DATAPOINT CORPORATION

1800/ 3800 & D.D.D.U.

EO's

ENGINEERING ORDER

CHANGE SHEET 1 ZONE C-6 AS SHOWN:

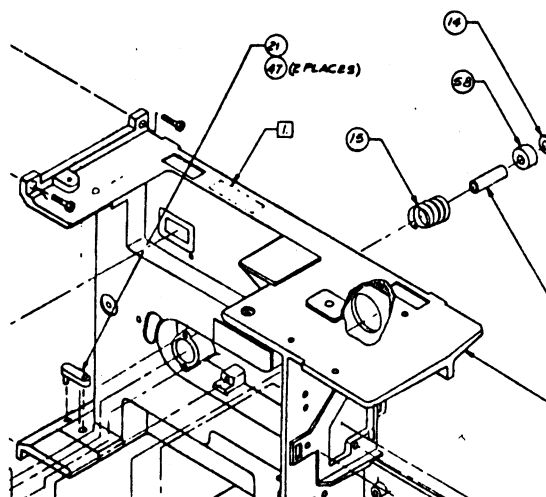
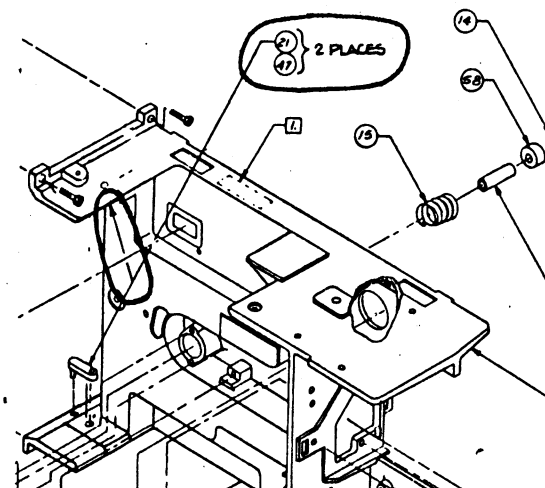
CHANGE REQUIRED:

CHANGE REQUIRED: CHANGE F/D, SHT 2 ZONE B-7 AS SHOWN:

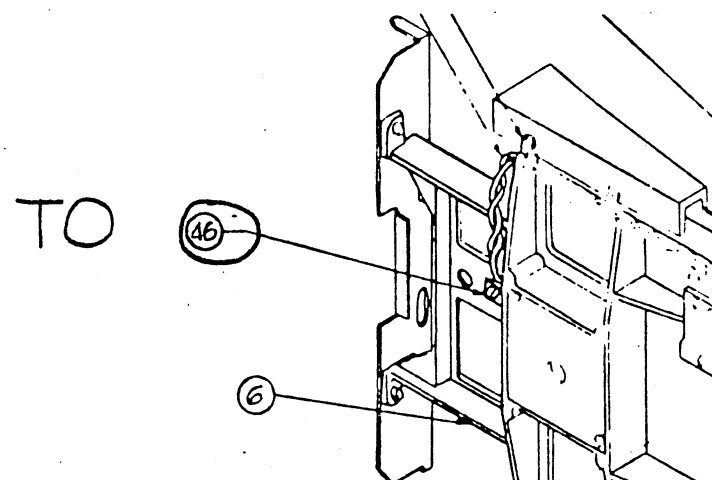
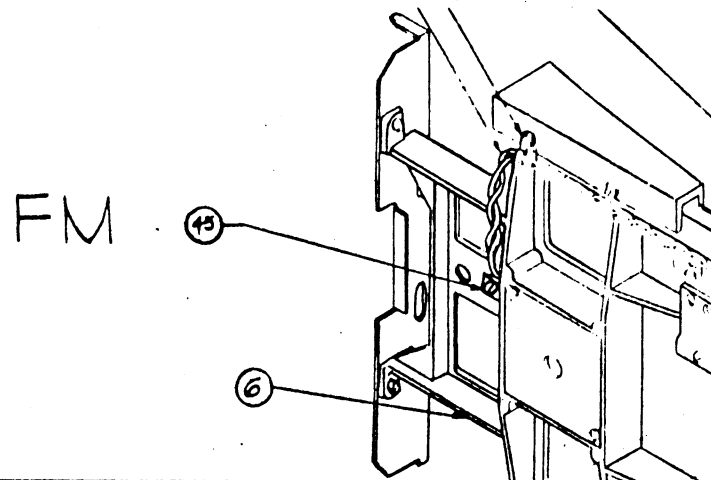
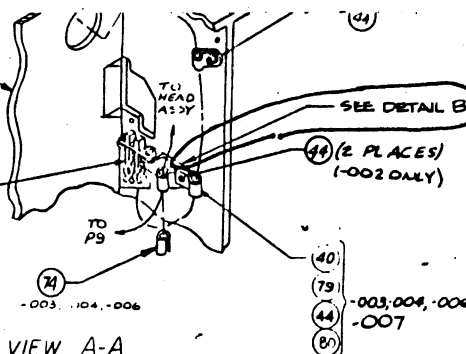
ADD TO F/D SHEET 2:

CHANGE 59-0443-001(A) AS SHOWN ZONE 4B

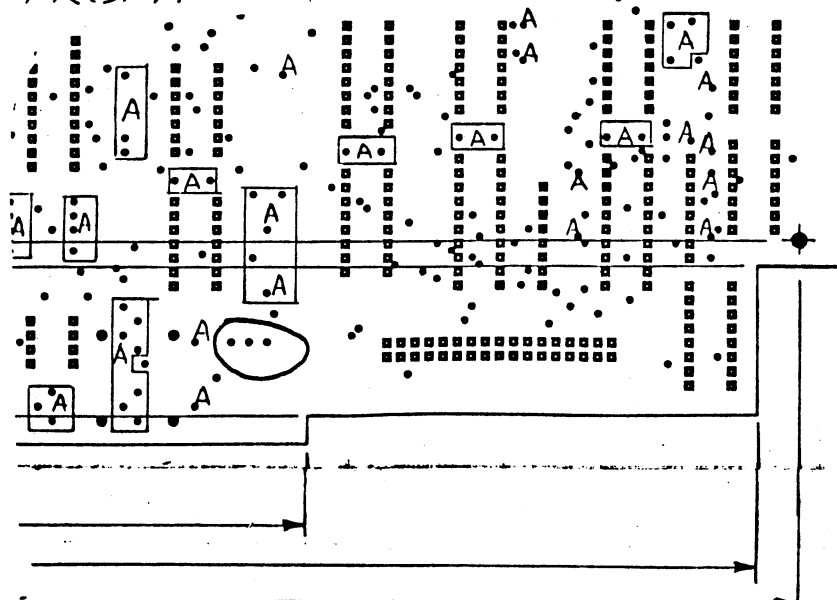
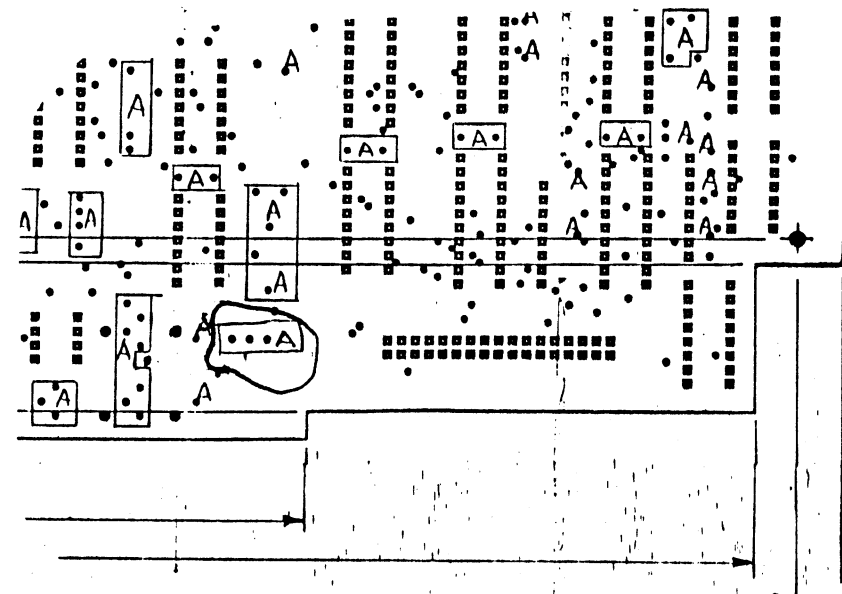
REASON FOR EO: TO INCREASE HOLE SIZES (ON J10) WHICH HAVE A .032 $\pm$.003 DIA. THE CONNECTOR PINS WHICH ARE INSTALLED ON THIS BOARD ARE SQUARE AND THEIR WIDEST POINT BEING .035 DIAGONALLY THIS IN-TURN CREATES A FIT PROB. THIS HOLE SHOULD INCREASE TO THE DIA. OF .038 $\pm$.003. THIS PROBLEM CONCERNS ONLY J10)

NOTE TO CAD: CHECK LIBRARY
SHAPE FOR PN 41-0423-002(B)
RECOMMENDED HOLE SIZE

NOTE:
"A" HOLES ARE
.038 ± .003

CHANGE F/D AS SHOWN:

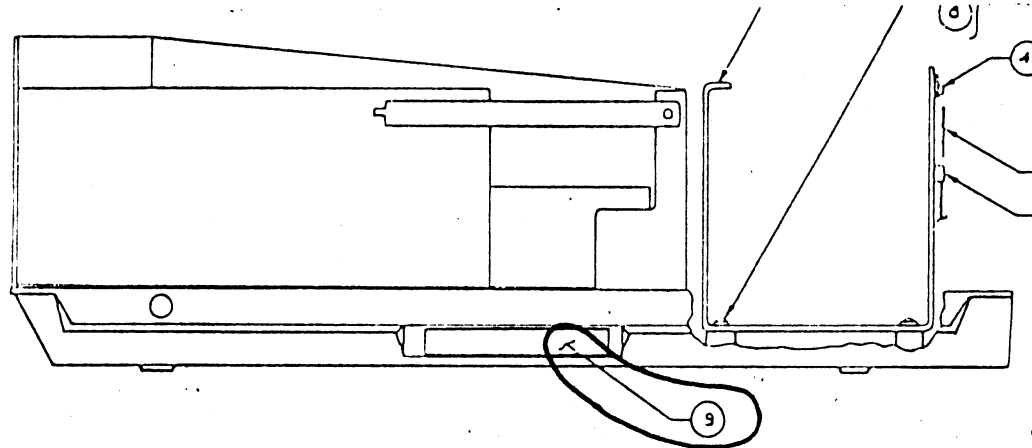
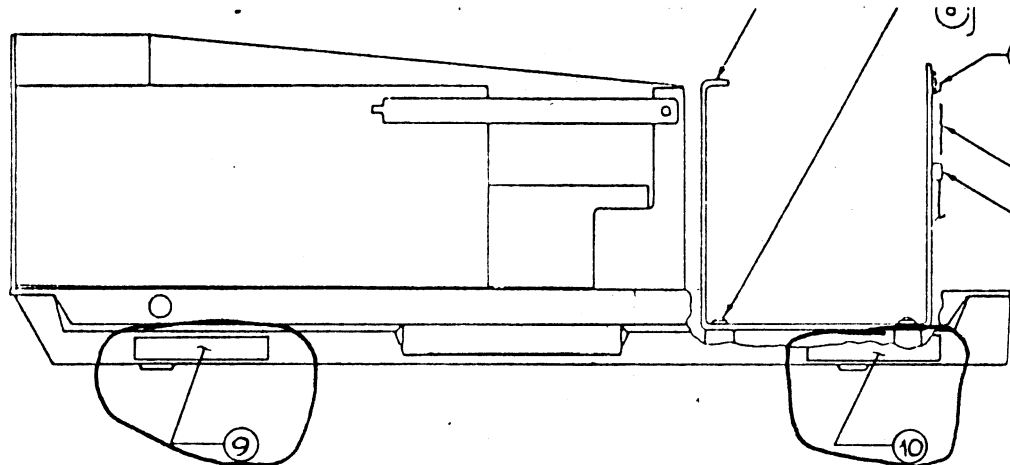
REASON FOR EO: CORRECTION OF LABEL LOCATIONS.

CHANGE REQUIRED: ON 10-0975 SHT 2 CHANGE VIEW A-A AS SHOWN:

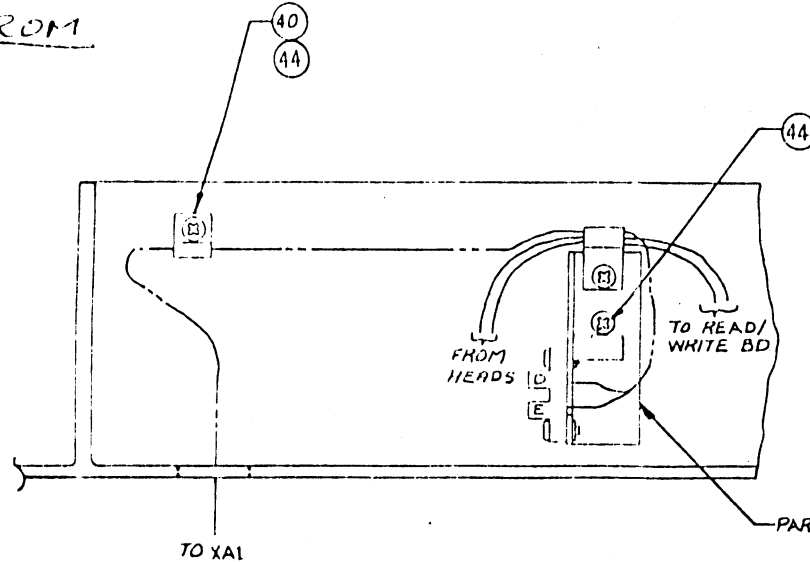
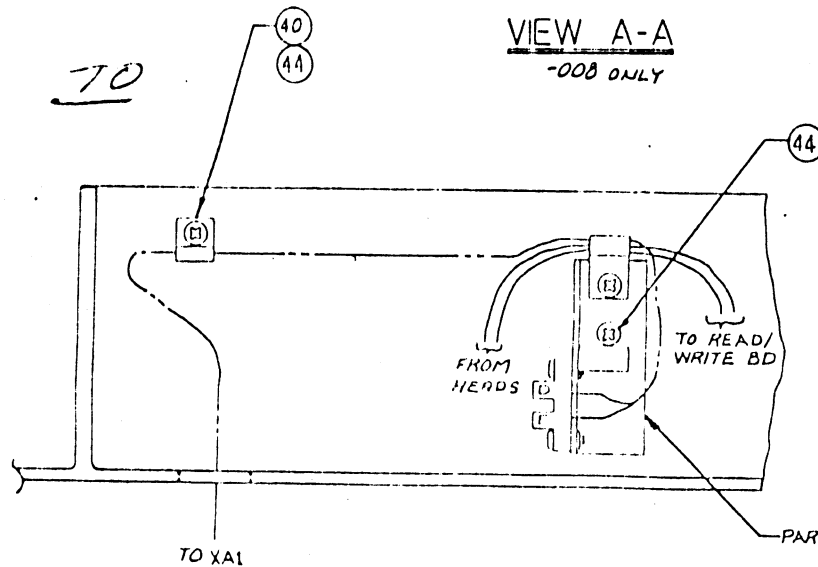
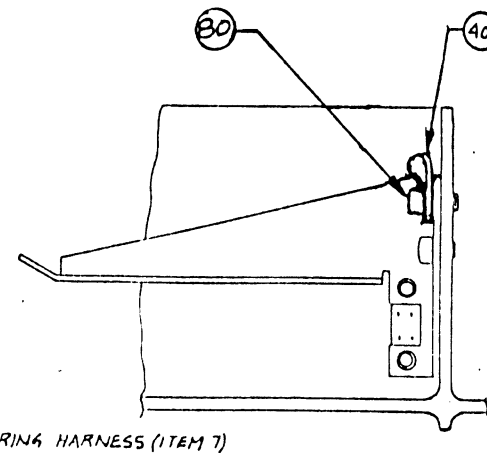
To SIMPLIFY INSTALLATION AND REDUCE MATERIAL. (FOR DUAL HEAD DRIVE)

CHG 01-0538-000(7) F/D ZONE C8 & C7 AS SHOWN
FROM

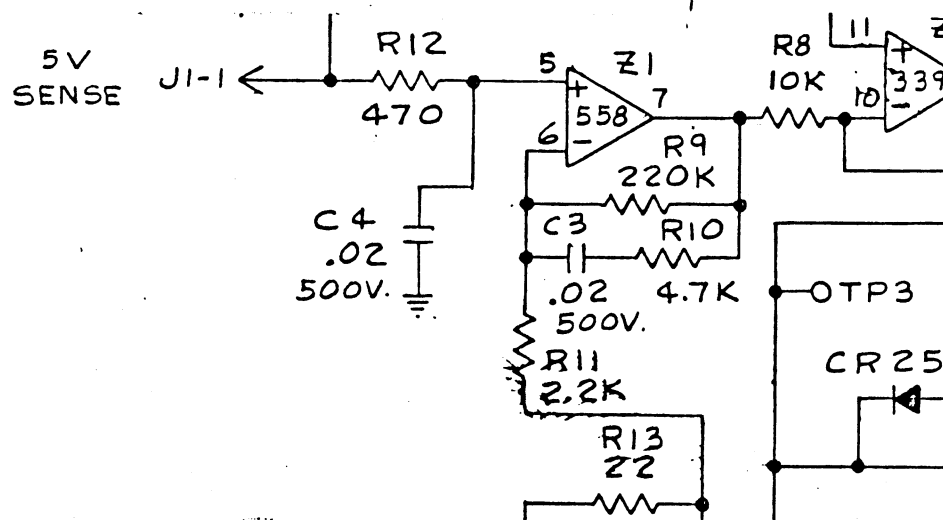
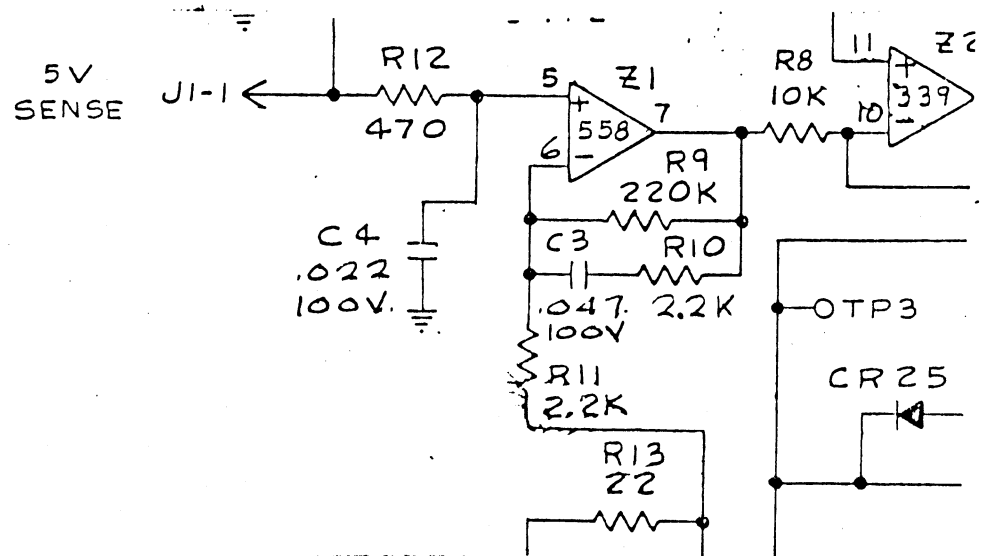
TO IMPROVE POWER SUPPLY
STABILITY.

ON F/D, ZONE A-8

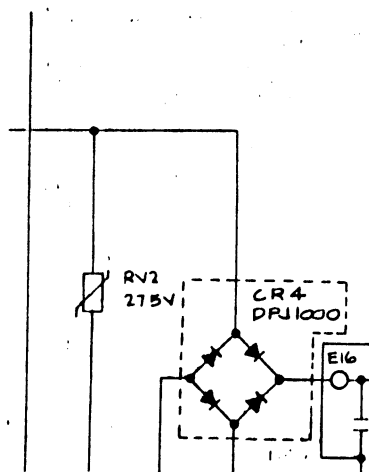
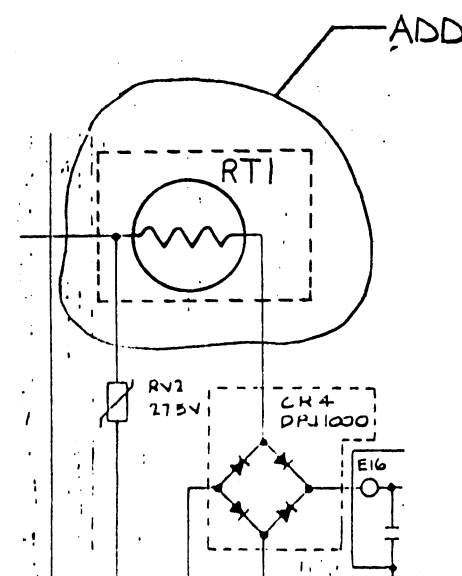
CORRECT THERMISTOR OMISSION
ON SCHEMATIC

FROM: 7. ITEMS INSIDE DASHED LINES ARE MOUNTED OFF BOARD, REFER ASSEMBLY 10-1138-001(U1A5)

CHANGE F/D AS SHOWN ON DWG 10-1341-001(3)

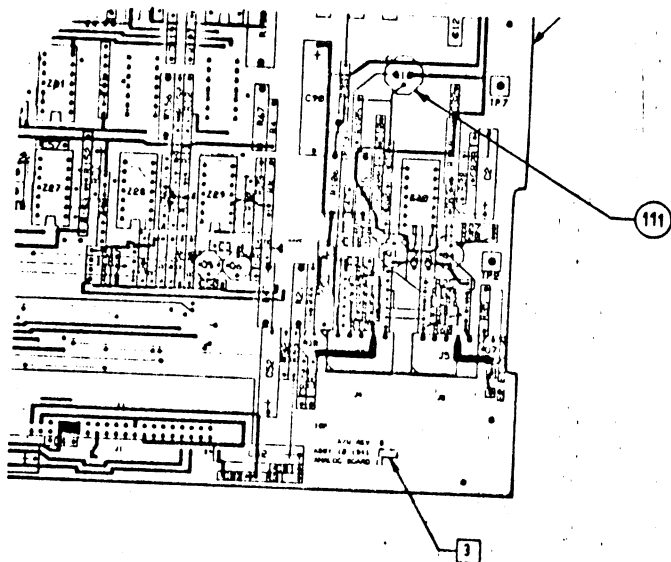
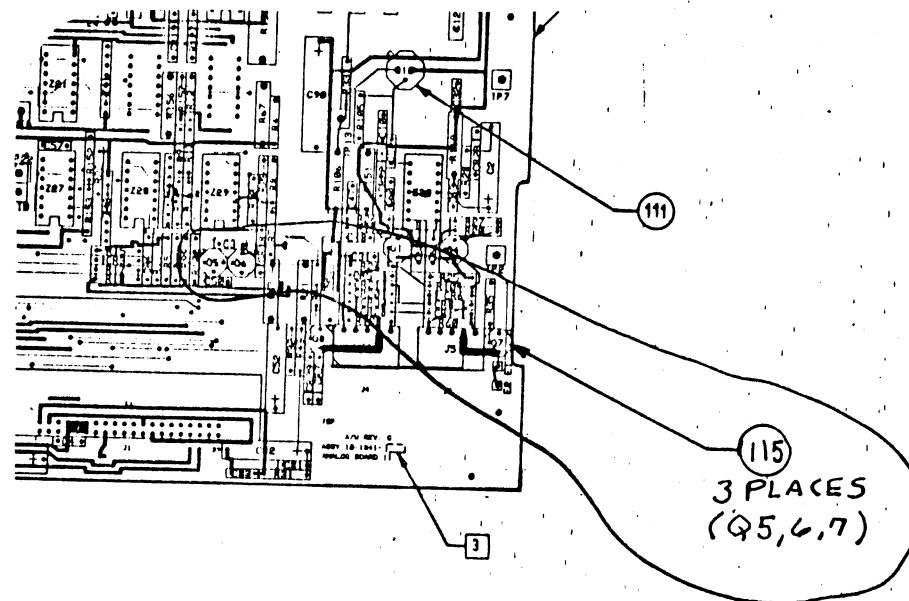
CHANGE REQUIRED: ADD THE FOLLOWING PART TO P/L 10-1341-001(3)

01-0570-001 SHEET 8
(FOR REF. ONLY)

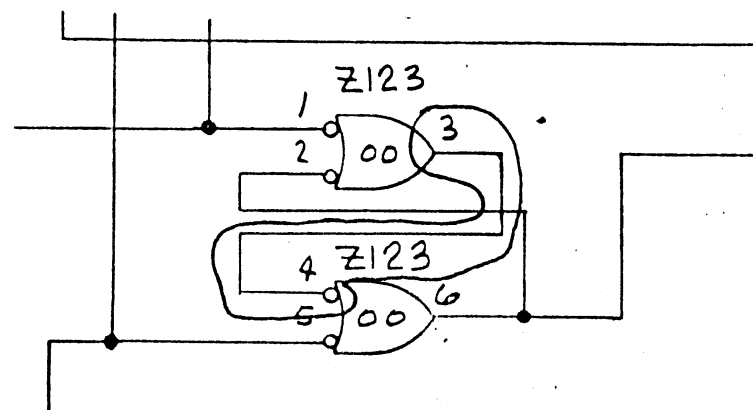
CAD: CORRECT A/W 04-0380
GROUND PLANE PER
SCHEMATIC DIAG. 01-0570 SHEET 8

DRAFTS: ON PWB 59-0443 REVISE
NOTE 2 WITH APPLICABLE A/W 04-0380
REV LEVEL.
